**16/00295/CONDT2 | Details submitted to discharge conditions in relation to planning ref: 16/00295/FULL1 Condition 19- Details of a scheme of landscaping | Matilda House Hillbrow Road Bromley BR1 4JL**

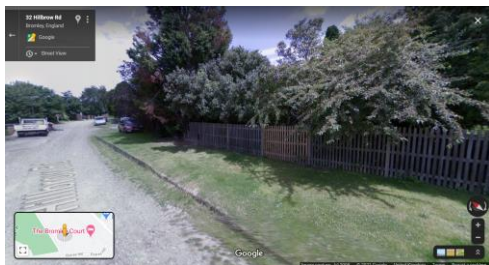
- 1No. Quercus Robur Fastigiata.

The usual version is 'Koster' which grows to 17-22m tall.
